Project Name and Assigned Application Number (SDP, SP or ZMA): Brookhill NMD

ZMA 2015-007

BROOKHILL SPECIAL EXCEPTION REQUEST

July 20, 2018

LANDSCAPE SCREENING EXHIBIT

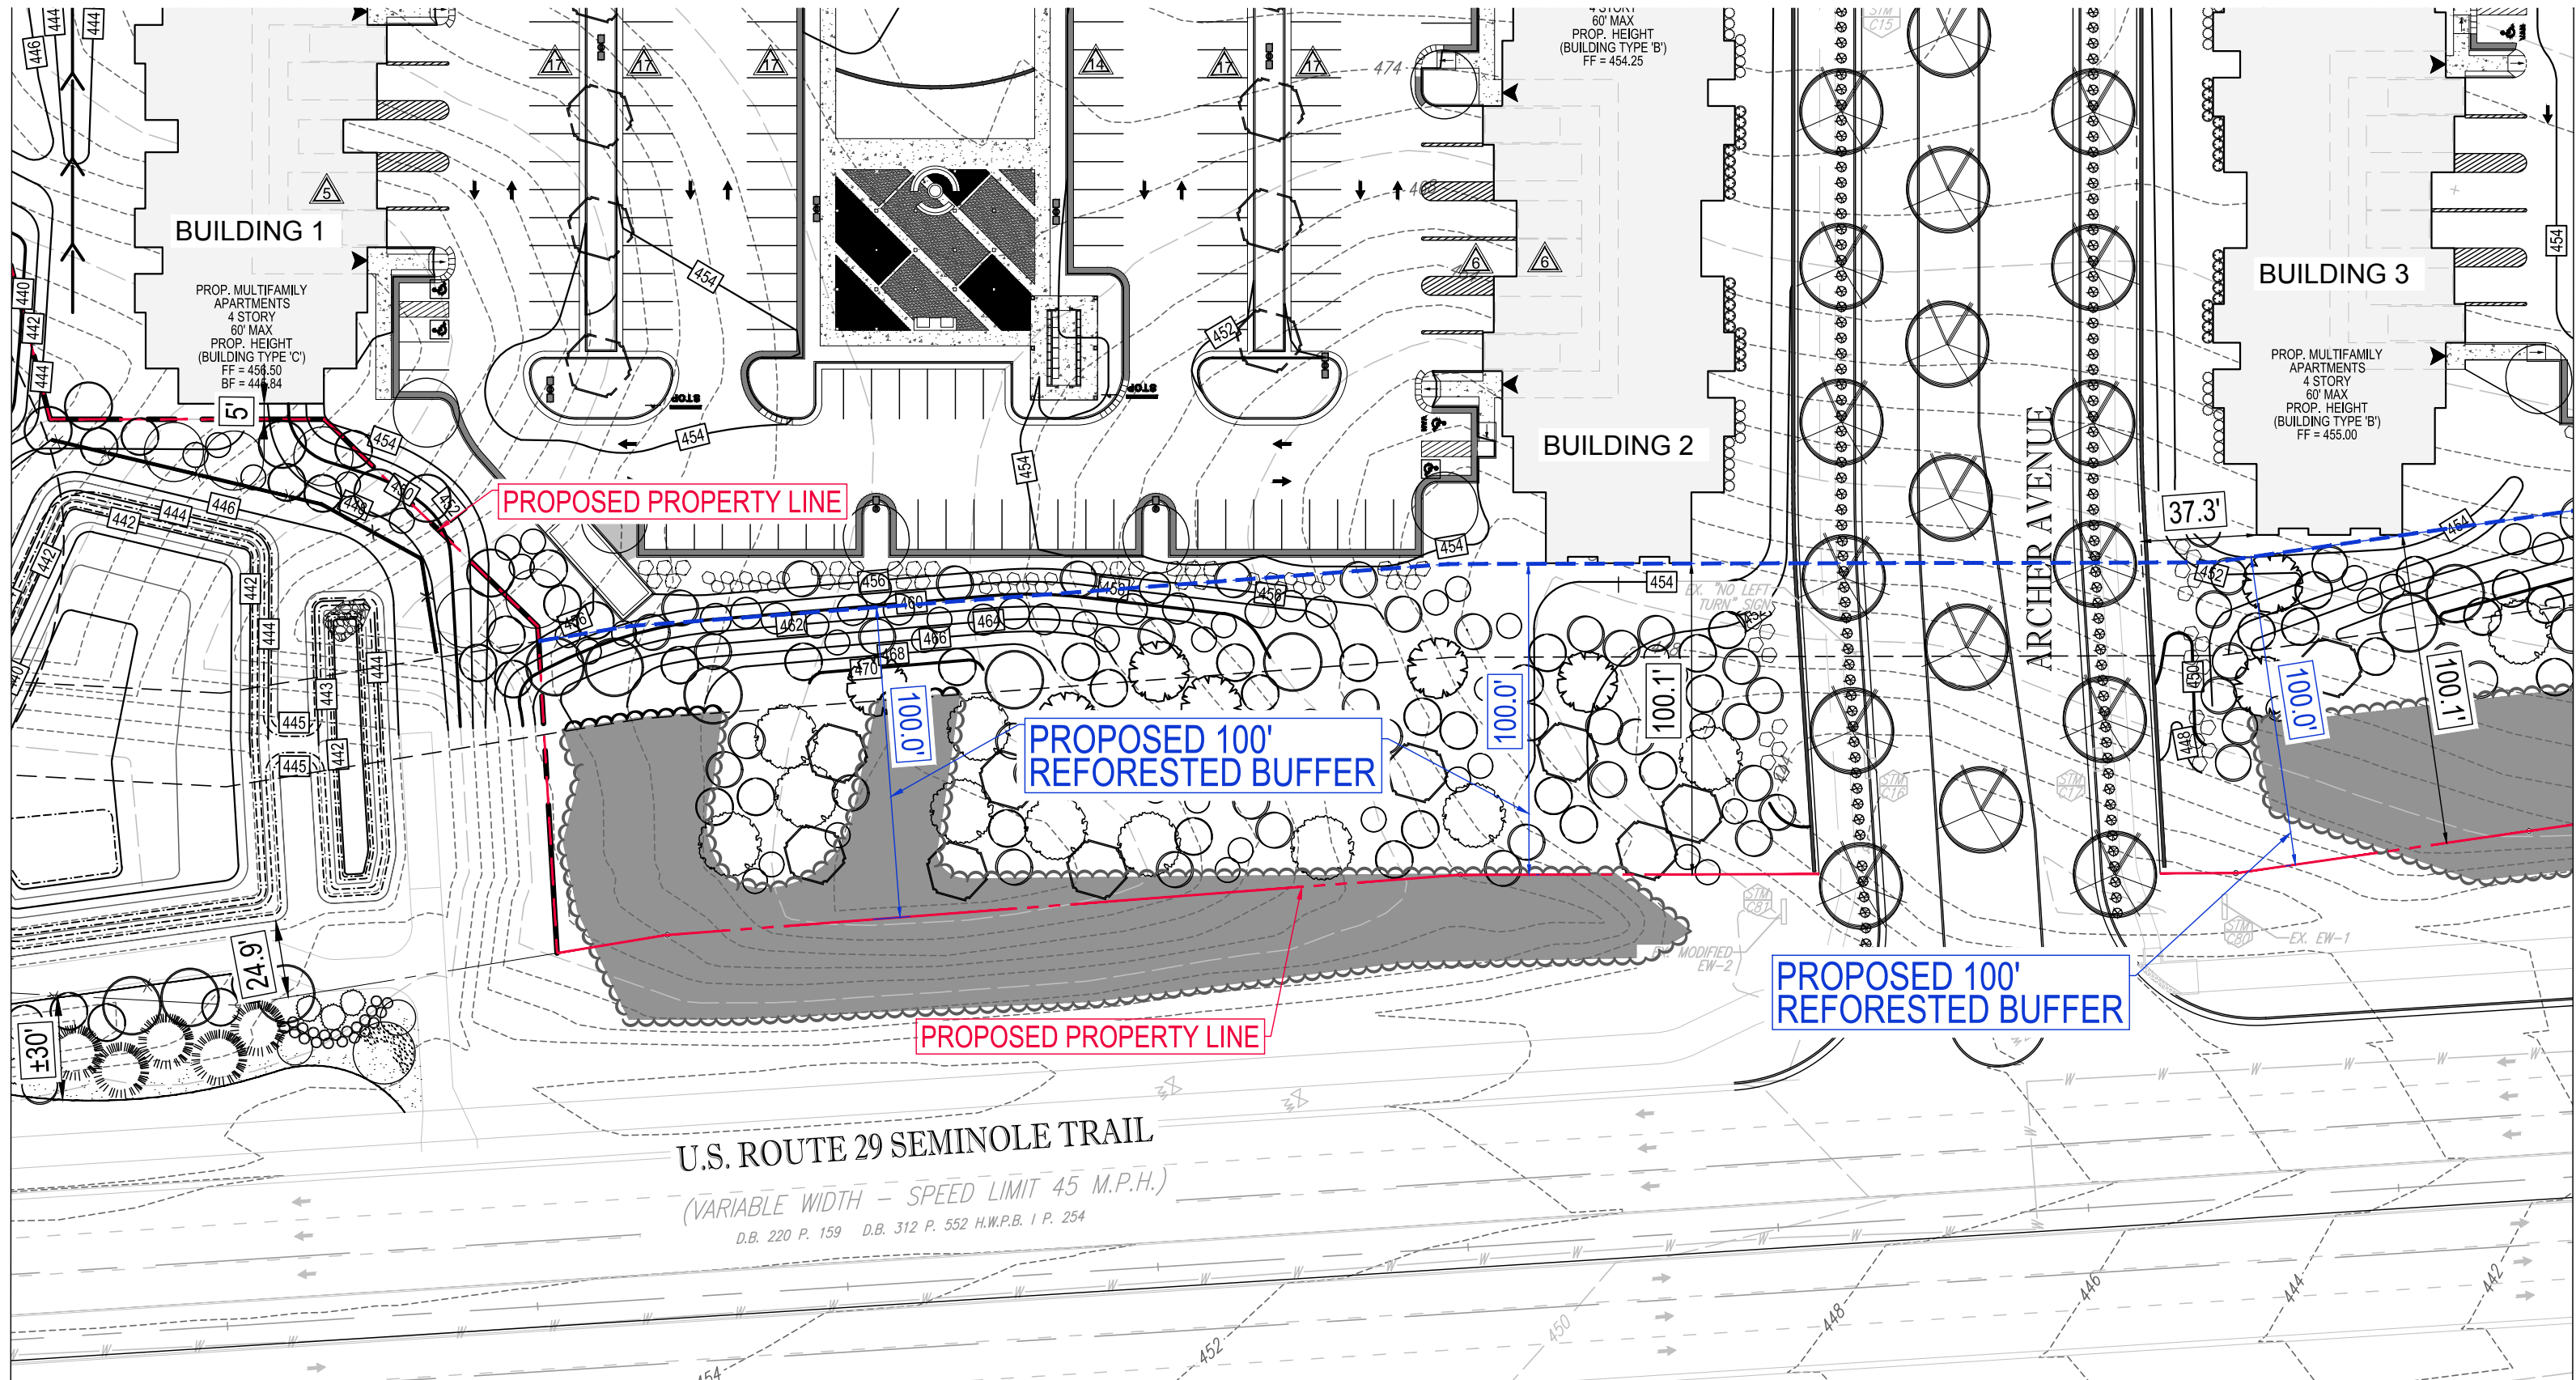
The Applicant has committed to provide 50 feet of buffer area in the vicinity of the Facility, however, due to the expanded size of the Facility, the total 50-foot area is not available in between the Facility and the proposed apartment building. Instead, this requested variation would allow flexibility for the full depth of the Stormwater Facility Buffer to be provided not just in between the Facility and the Development, but also in between the Facility and the Entrance Corridor. The area between the Facility and Route 29 includes land within the VDOT right-of-way, however VDOT has already agreed to allow the plantings as shown on our exhibit and the necessary easement document is underway.

Thus, the 50-foot requirement could be successfully accomplished using both areas. This option creates far superior screening from the Entrance Corridor because both the proposed expanded Facility and the Development will be appropriately screened from view. The attached rendering demonstrates the proposed landscaping of the expanded Facility compared to the existing conditions. The proposal also includes the removal of the existing chain link fence surrounding the Facility and replacement with a more attractive dark metal fence, as preferred by the Architectural Review Board.

We request relief from the 50-foot buffer requirement in between the Facility and the Development in order to provide a solution which splits the buffer area to buffer both the Facility and the Development. The full 50-foot depth of buffering will be accomplished with this request; however, the area in between the Facility and Route 29 will be utilized.

BROOKHILL - BLOCK 4 APARTMENTS SETBACK EXHIBIT

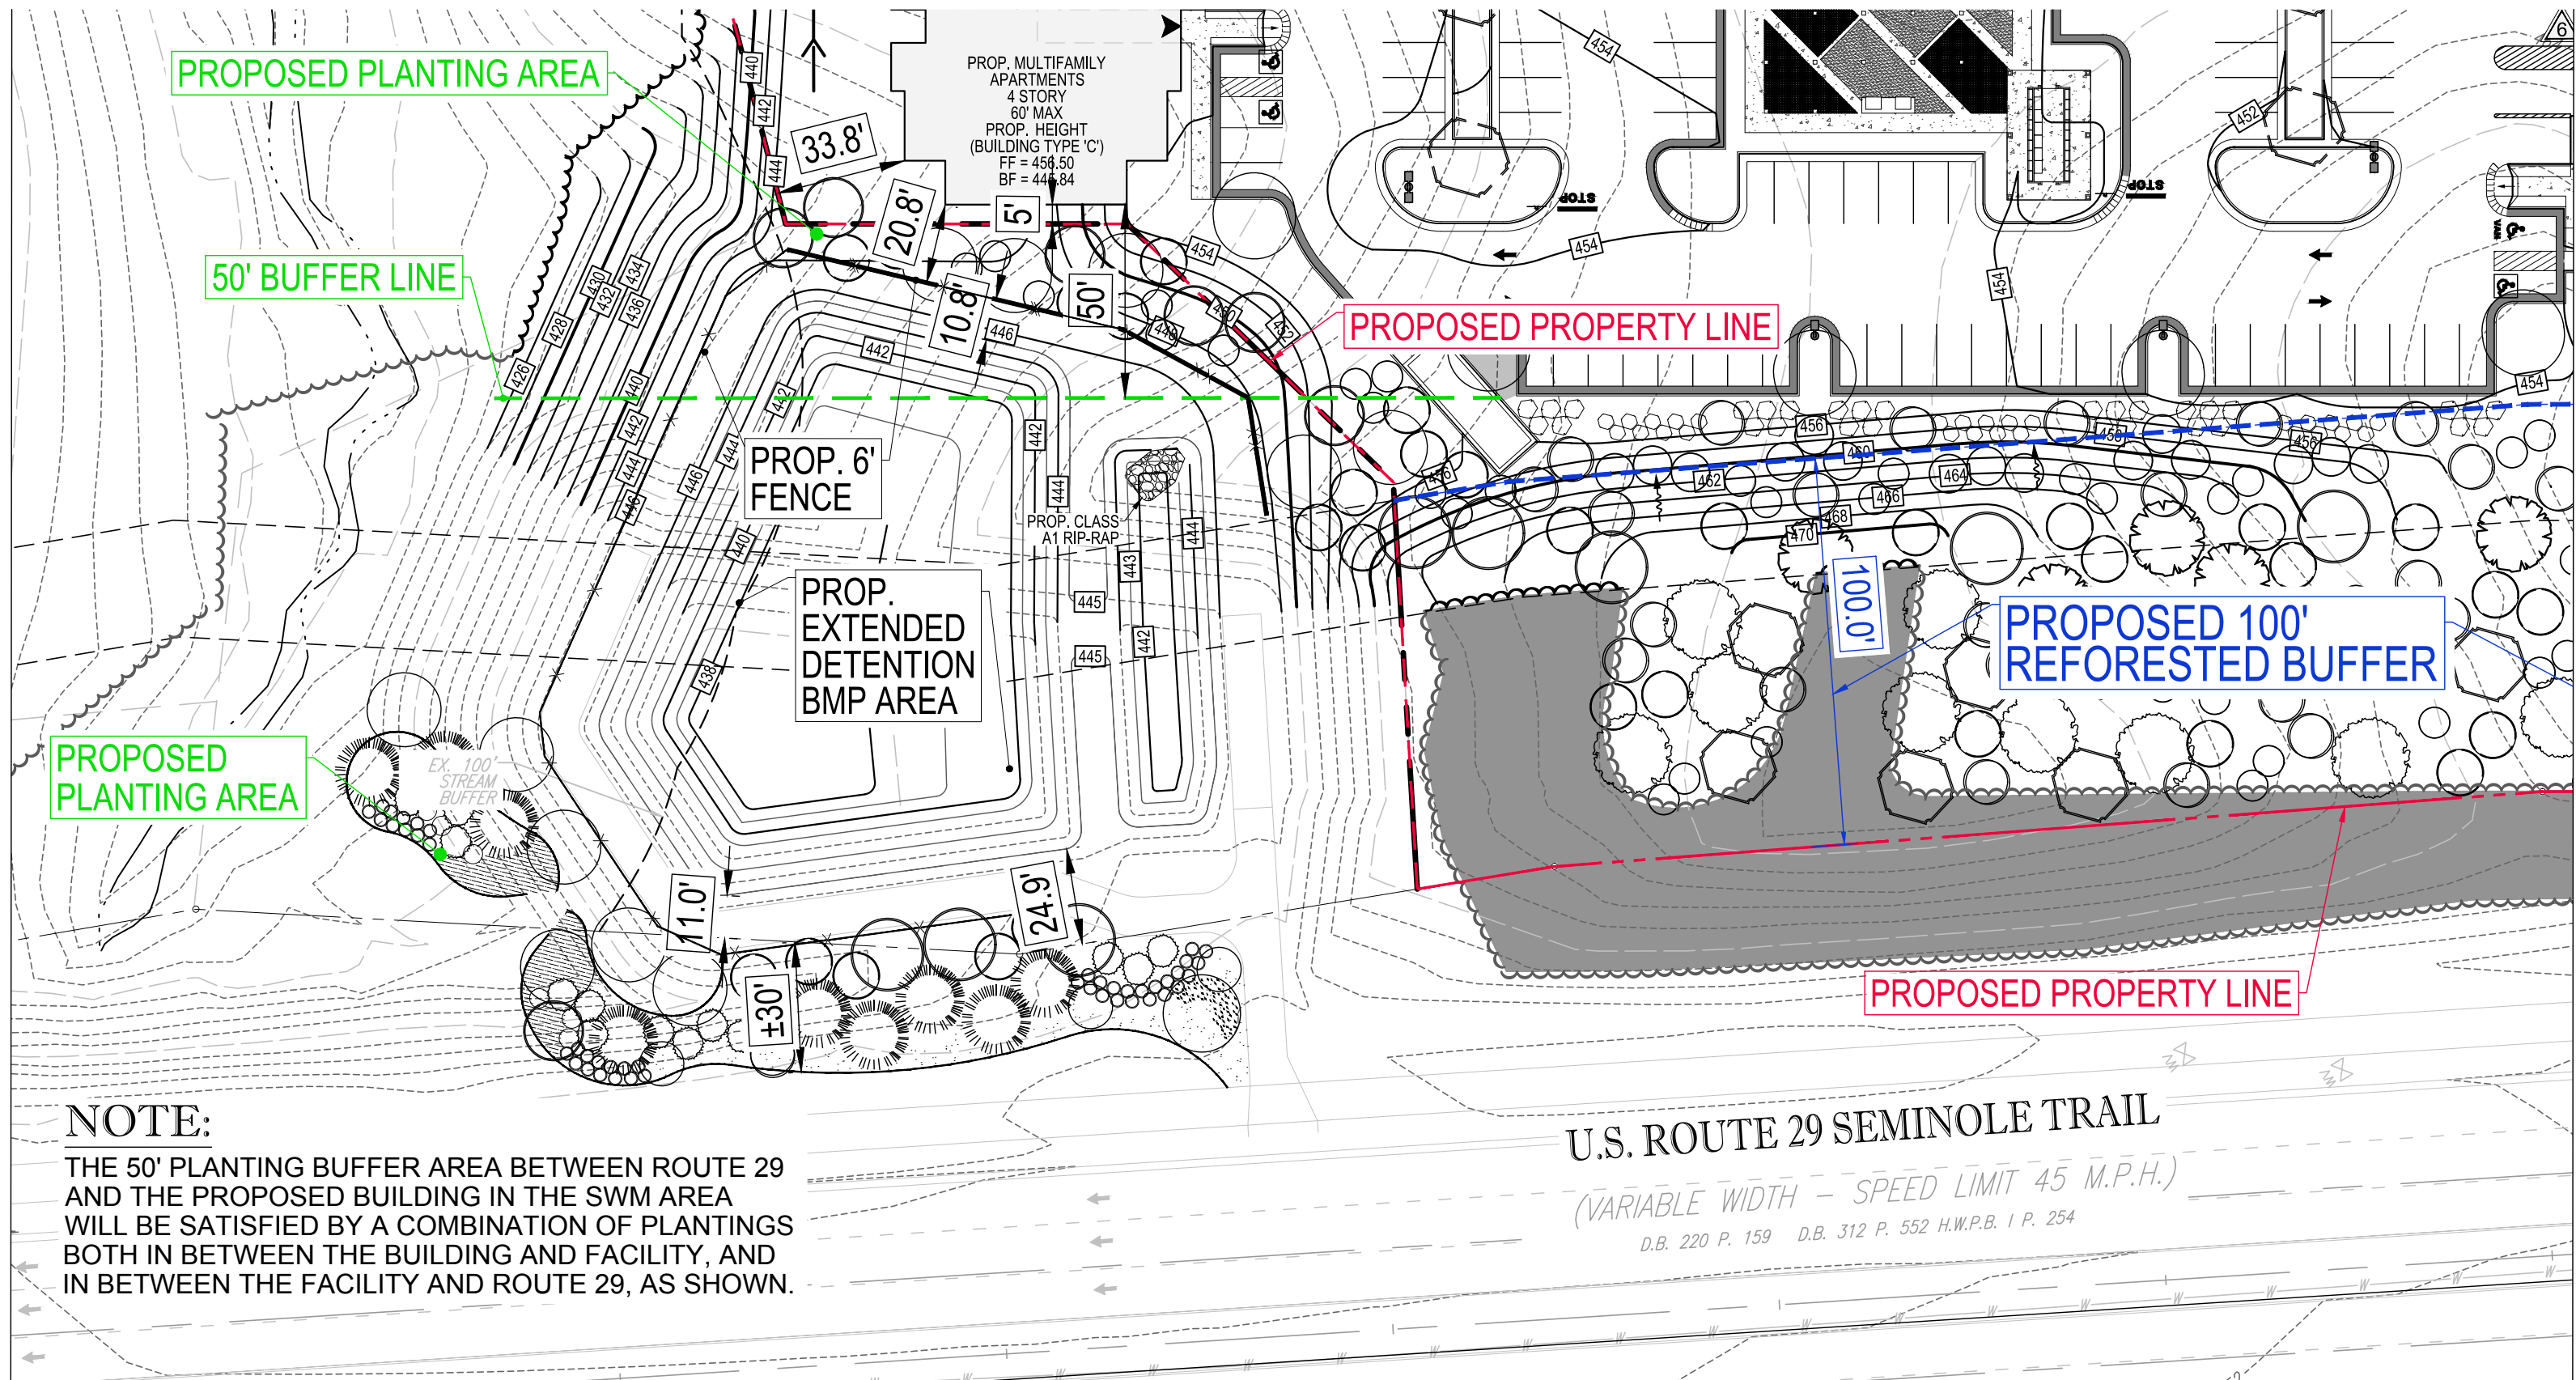
We request relief from the 10-foot minimum rear setback requirement for Block 4 as established on page 17 of the Code of Development in Table 2.3.2.2. The notes section of this table states: "Rear setback for Block 4 shall be adjacent to the Route 29 Buffer". The Application Plan and Code of Development are attached for your reference. As noted previously, the Route 29 Buffer already provides at minimum a 100-foot setback along the Route 29 frontage that will be extensively landscaped due to the Applicant's reforestation efforts.

The Development of Block 4 includes multiple apartment buildings and associated parking and support structures. There are three areas within the Block 4 site plans in which the 10-foot rear setback is not met, as shown in the attached exhibit. We contend that the 100-foot setback established by the Buffer is more than adequate in this case and the addition of 10 feet of setback adjacent to the Buffer is not necessary and does not provide any additional public benefit. Renderings of the proposed Development from Route 29 are also attached, demonstrating the extensive buffer area and providing a simulation of the reforestation efforts of the Applicant.
